## Report to the Hearing Committee on a notified resource consent application

- Activity:** To undertake construction works associated with the Pinehaven Stream Improvement flood mitigation works in the bed of the Pinehaven Stream.

- File Reference:** WGN200083
- Applicant:** Upper Hutt City Council
- Consents Sought:**
- [36459]: Discretionary Activity**  
Land use consent to undertake works in the bed of the Pinehaven Stream involving the placement, replacement and removal of structures; and the construction of naturalised channel banks, in relation to the Pinehaven Stream Improvement flood mitigation works, including associated disturbance and deposition to the streambed.

Figure 3: Planting of indigenous riparian species in the stream corridor which can tolerate wet conditions (DCM Urban Design Page 18).

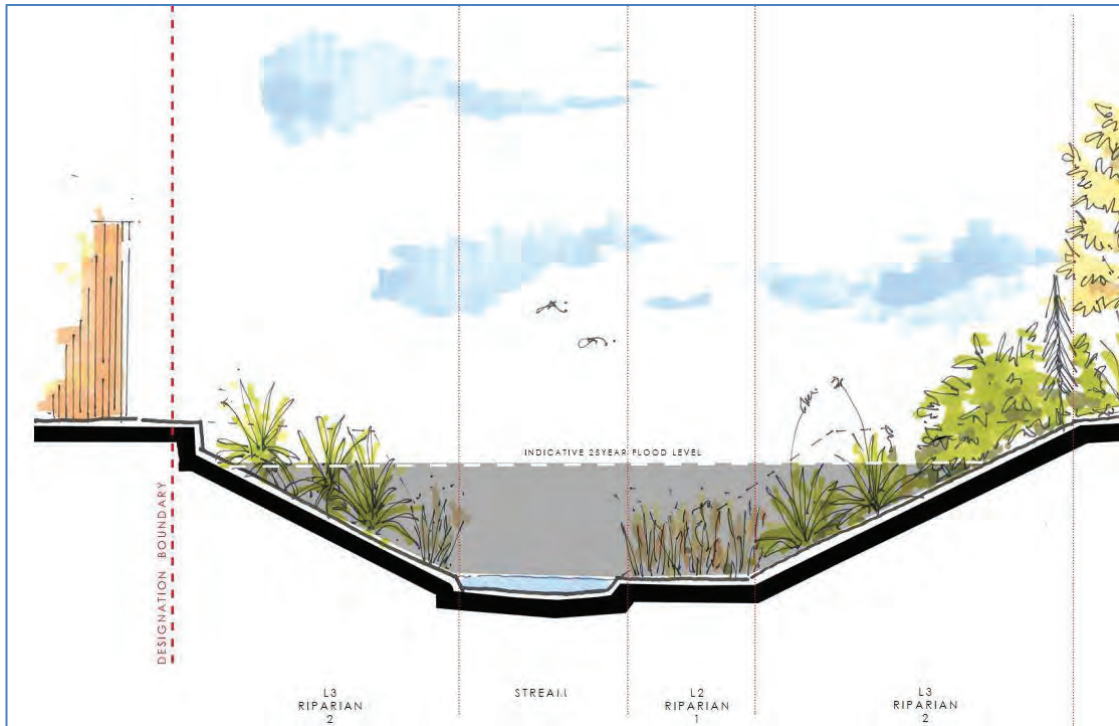
The DCM Urban Design (2019) landscaping plans and plant schedule include areas labelled riparian rarely wet and riparian partially wet. Examples of cross sections for these planting types are shown in Figures 3 and 4. The streambank planting plans include a mix of species that will not grow so tall as to densely shade neighbouring houses. However, the L3 Riparian 2 list includes nine species, only two of which (*Austroderia fulvida* and *Veronica stricta* var. *atkinsonii*) are naturally-occurring in the catchment. *Ficinia nodosa* and *Muehlenbeckia astonii* are both coastal species and unlikely to be successful alongside what will, at times, be a fast-flowing stream, and the *Carex* species are likely to be overwhelmed by weeds such as *Tradescantia fluminensis*. Short-stature, sun-loving species that hold the stream banks along with appropriate flood-resistant understorey species are required for this area.

Figure 4: Planting of indigenous riparian species in the stream corridor to soften the visual impact of engineered walls (DCM Urban Design Page 30).

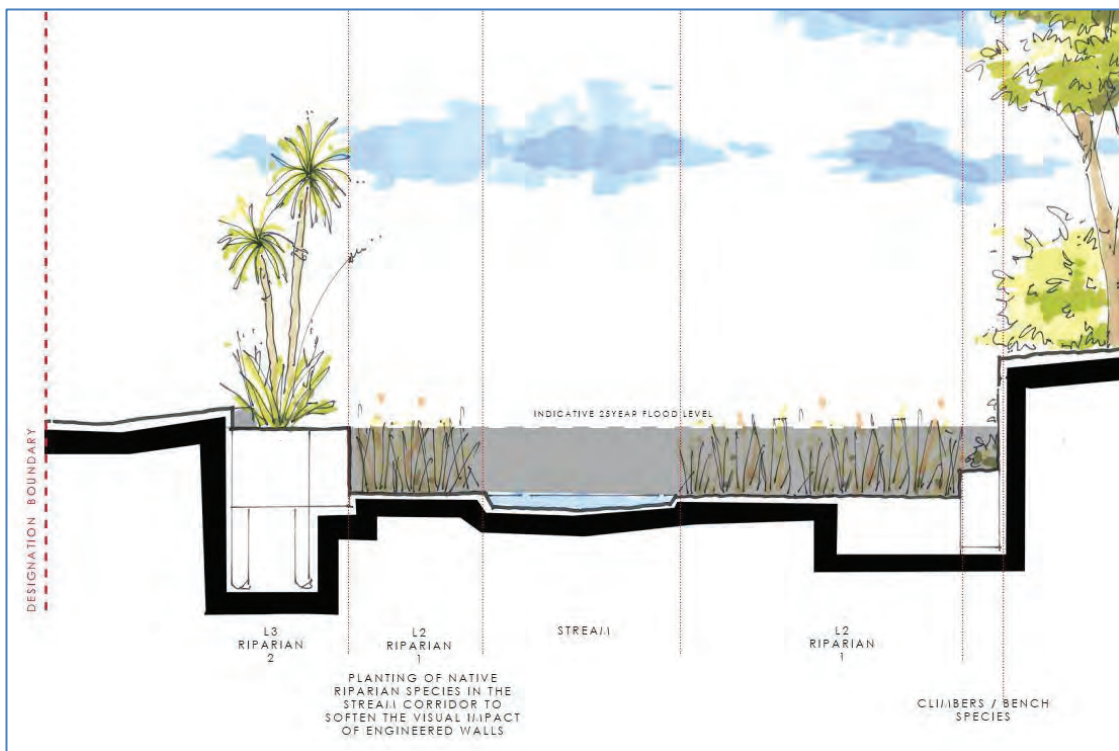
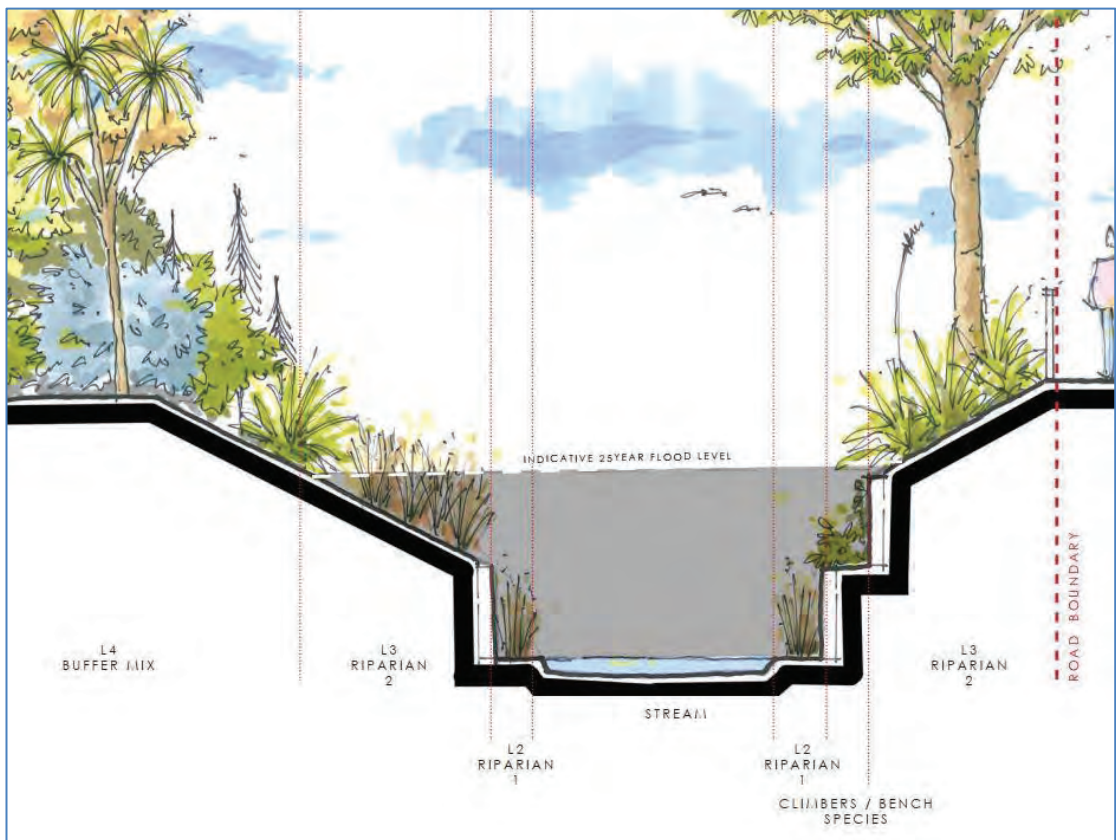
DCM Urban Design cross sections (Figures 4 and 5) show planting in the active channel of the stream close to the water's edge. This is inappropriate because it reduces galaxiid spawning habitat and would encourage the deposition of fine sediment.
